SUBDIVISION REVIEW SHEET**CASE NO.:** C8J-2020-0148**P.C. DATE:** July 27, 2021**SUBDIVISION NAME:** Prospect Park Preliminary Plan**AREA:** 234.52 acres**LOT(S):** 806**OWNER/APPLICANT:** Carma Easton, LLC
(AJ Zorn)**AGENT:** Carlson, Brigrance, and Doering, Inc
(Brett Pasquarella)**ADDRESS OF SUBDIVISION:** Apogee and Ausblick**GRIDS:** K12**COUNTY:** Travis**WATERSHED:** North Fork Dry Creek**JURISDICTION:** Limited Purpose**EXISTING ZONING:** Planned Unit Development (PUD)**MUD PLAN:** Pilot Knob MUD**DISTRICT:** 2**PROPOSED LAND USE:** Residential- Single Family; greenbelt, landscape/ drainage easement lots, and public ROW**VARIANCES:** None**SIDEWALKS:** Sidewalks will be provided along all internal streets and the boundary street.

CITY OF AUSTIN – TRAVIS COUNTY – SINGLE SUBDIVISION OFFICE
SUBDIVISION APPLICATION – MASTER COMMENT REPORT

PROJECT NAME: Prospect Park Preliminary Plan
LOCATION: 7931-1/2 APOGEE BLVD

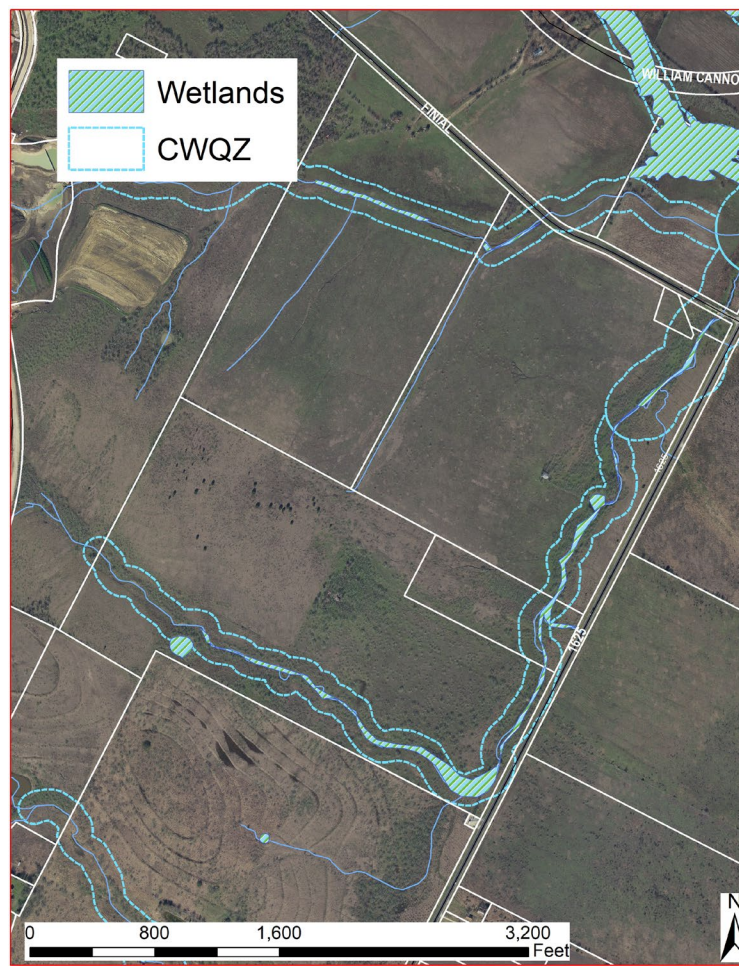
WETL 1. **Update 0** This project does not comply with Critical Environmental Feature protection

requirements. [LDC 25-8-281 or LDC 30-5-281; LDC 25-8-282 or LDC 30-5-282; ECM 1.10] and compliance with PUD Ordinance 20161110-032 Part 12 Section G-9 cannot be established. Additional information: {*CEFs on site not shown*; see map below}

TYPICAL JOINT ACCESS EASEMENT DETAIL
& TYPICAL QUAD DRIVEWAY

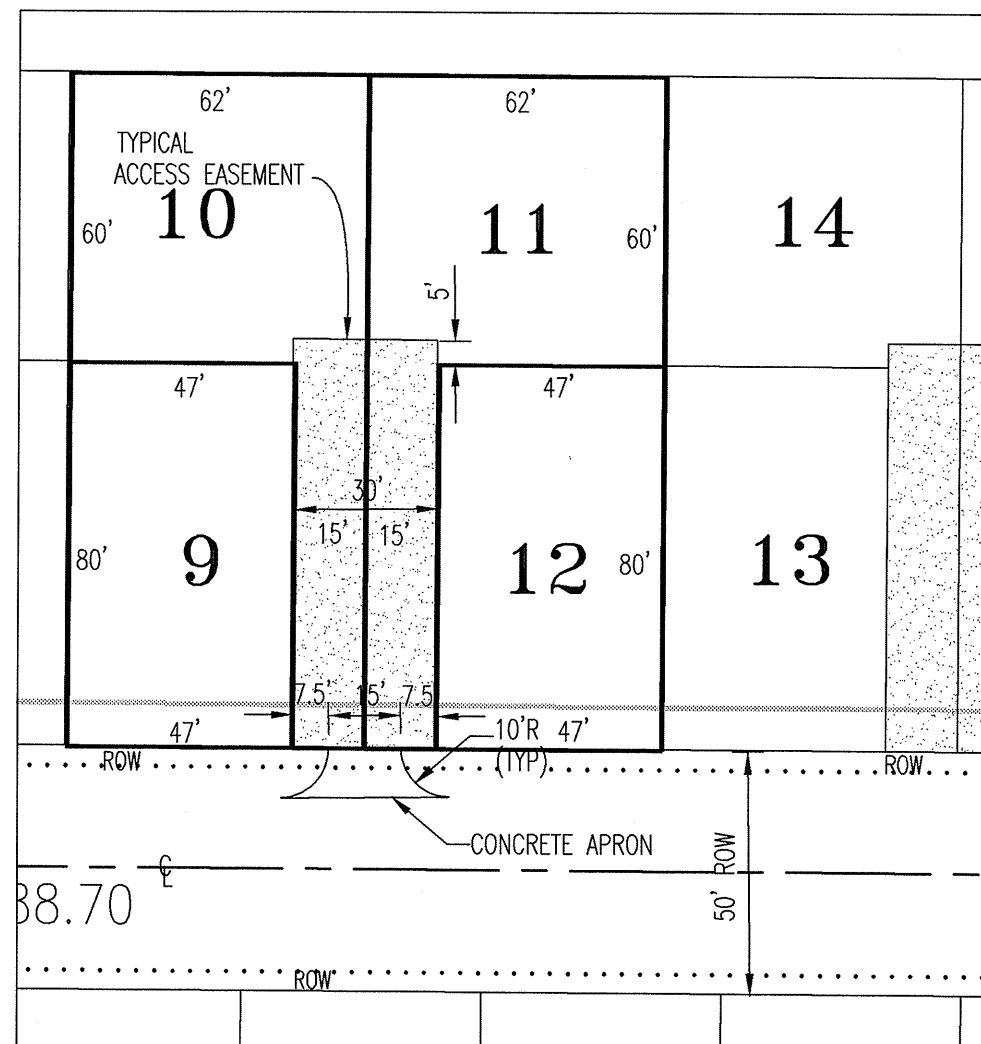
- 1) Modify the Typical Joint Access Easement Detail & Typical Quad Driveway to show a 56' right-of-way.
